Project: **Newgate Lane, Fareham**  
Client: **Bargate Homes and Sustainable Land**  
Subject: **Rebuttal**

Document ref: **FL&BH 3.4**

### **Rebuttal by Miss Martha Hoskins**

**Outline Planning Application for Land at  
Newgate Lane (North), Fareham**

Figure 1 - Newgate Lane East Northbound AM Degree of Saturation Readings for 190 Dwellings

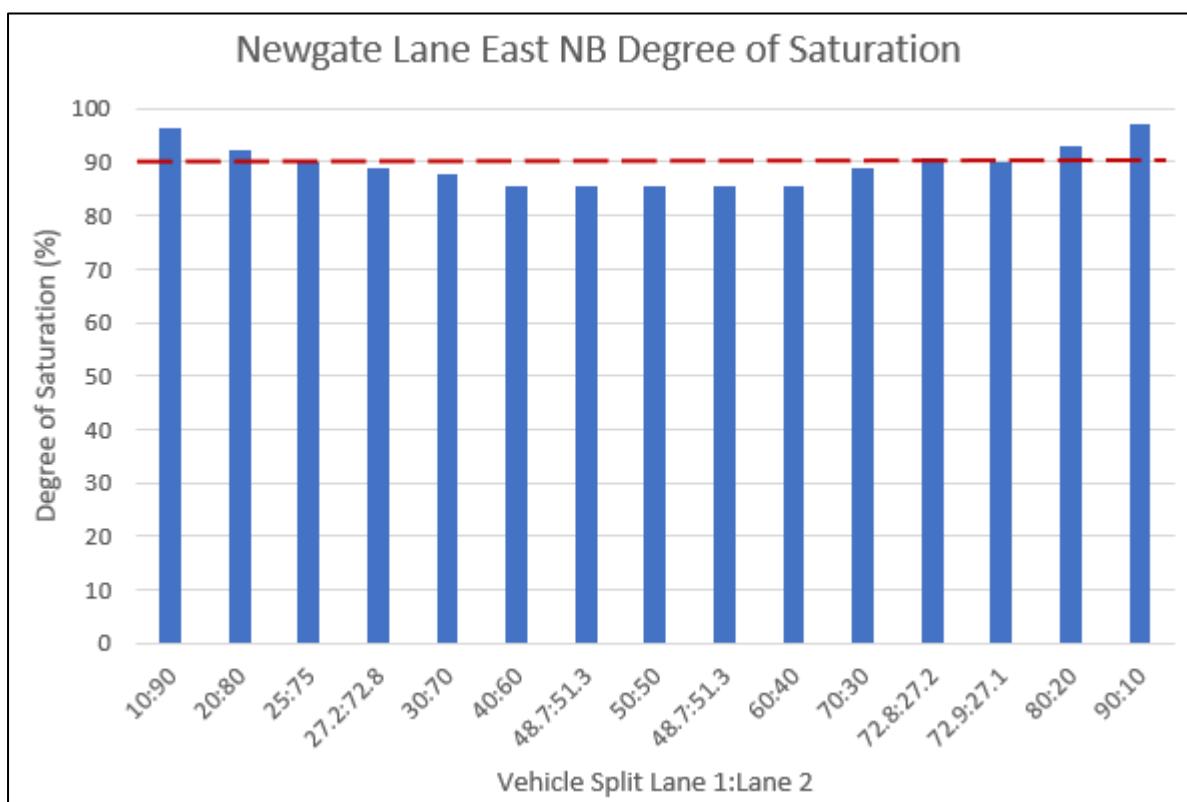
- 6.4. Results are presented below in figures 1 and 2 assuming a variety of vehicle splits for the AM. The PM results presented in my PoE show the junction operates well within capacity in the PM peak. The full results can be found in Appendix B of this rebuttal. Below I have demonstrated the practical reserve capacity (PRC) of the junction and the degree of saturation (DoS) for the northbound approach.

- 6.5. As previously mentioned, the modelling has been undertaken for a variety of vehicle splits across the two lanes. Between 10:90 and 50:50 the assessment assumes the effective flare is lane 1 or the nearside lane. Between 48.7:51.3 and 90:10 the effective flare is assumed to be lane 2, the offside lane.

- 6.6. 72.8:27.2 is the vehicle split suggested in JMPoE and as such has been modelled for 27.2:72.8. as well. 48.7:51.3 shows the vehicle split if LinSig were to assign the flows based on their delay; essentially the model assigns the flow in a way that it will experience the lowest volume of delay.

- 6.7. 25:75 and 72.9:27.1 shows the vehicle splits required if the junction were to operate with its highest degree of saturation being 90% and a PRC of 0%. Effectively this shows the vehicle splits for the junction to operate at capacity. As noted in paragraph 6.3 of NGPoE this is widely accepted as the maximum acceptable DoS.

Figure 2 – AM PRC Results for 190 Dwellings

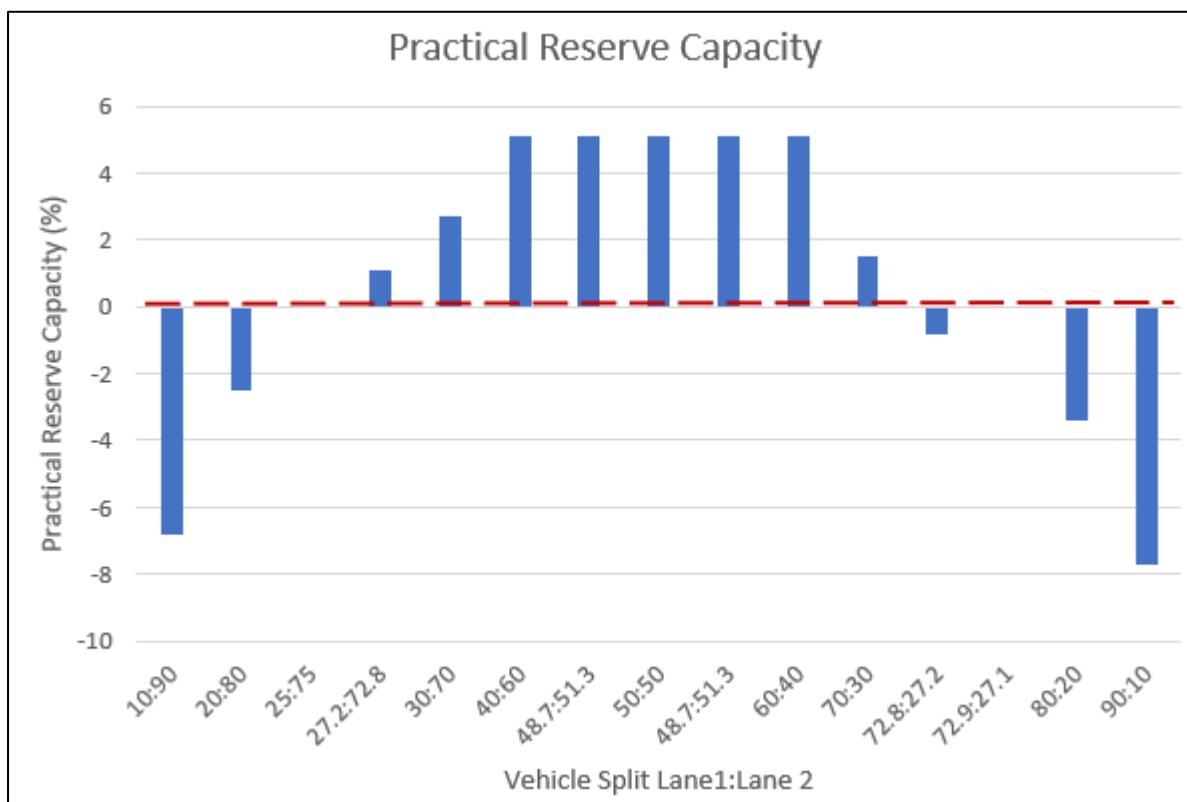
- 6.8. The DoS and PRC results demonstrate that the junction will operate within capacity at a wide variety of vehicle splits across the two lanes. DoS is the most common method of assessing how a junction operates; delay and queuing in modelling is unstable and fluctuates greatly when minor amendments are made to the model.

- 6.13. In paragraph 6.3 of NGPoE it is accepted that 90% is the maximum acceptable DoS and we demonstrate the junction will operate below this at the vast majority of vehicle splits and all those below 80:20. Road users will naturally seek to achieve this DoS to avoid any latent queuing.
